Subject: 210 PCH - 5/21 Hearing

RE: 210 PCH

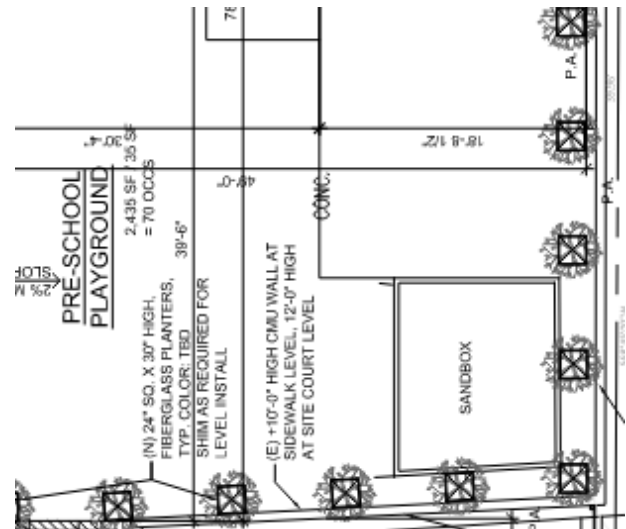
Additionally, **no sampling was done where a lot of work occurred on cars/painting in the back garages**, nor in the area where the **playground** is planned. You can see in the image to the left there were multiple outdoor work areas and painting booths where the soil was not tested for environmental hazards and contaminants,

From the report, **they only sampled and remediated where the green boxes are**. The red circles are where they temporarily laid the contaminated soil. In the **proposed play yard**,

you can see where there were many car paint booths in the past.
